# Hitting the Target: ENERGY STAR SSL Outdoor Lighting Criteria

DOE Webcast  
October 8, 2009

## Presentation Overview

## Pole-Mounted 07/01/09 Draft Criteria

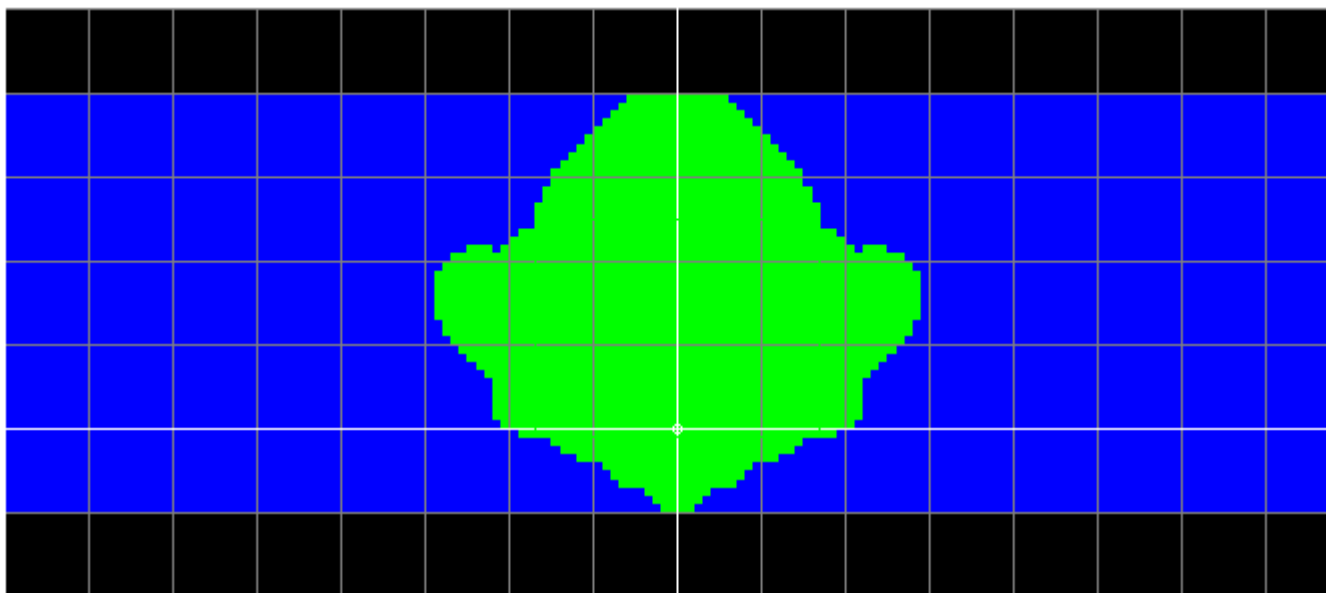
- Comment
  - Did you consider using Target Efficacy Rating (TER) as defined in NEMA LE 6-2008?
- Response

- Comment
  - Did you consider using Target Efficacy Rating (TER) as defined in NEMA LE 6-2008?
- Response
  - TER was evaluated but not adopted because neither uniformity nor shape of distribution are evaluated, and due to improper treatment of backlight.
  - A possible revision, to include backlight to 1.0-MH for Types **II-III-IV**, would be a major improvement.
    - ❖ Vote scheduled for 10/07/09 (yesterday).
